## Determination 2018/046

# Regarding the refusal to issue a code compliance certificate for alterations to a 16-year-old building at 176 McLeod Road, Te Atatu South, Auckland

**Figure 2: The 2012 alterations**

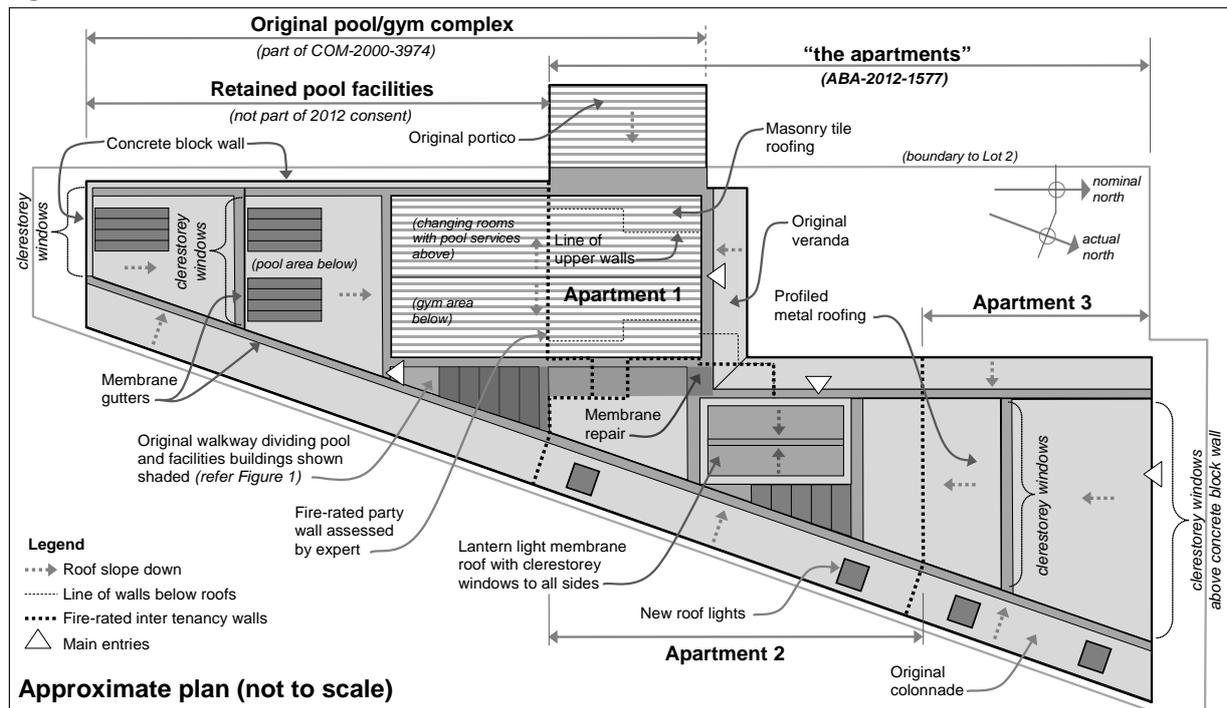
5.1.7 In regard to 'those elements of the existing construction upon which the performance of the new build depend', the expert discussed this with the relevant authority official who confirmed the content of his email of 12 February 2018 (see paragraph 3.6.2) that the only outstanding issues are (see Figure 2):

- original elements abutting the Apartment 1/pool area firewall (see paragraph 5.4.1)
- the repaired roof and gutter areas (see paragraph 5.3.2).

5.3.2 In regard to previous roof repairs above the Apartment 1 to 2 junction (see Figure 2), the expert noted that:

- the repaired area is small and there is minor ponding to an adjacent area
- there is no information on the reason for the repair, so it is unclear whether work would have been exempt under Schedule 1 from requiring a consent

- taking account of the above, any prior leak therefore appears to have been adequately repaired and has performed to date.
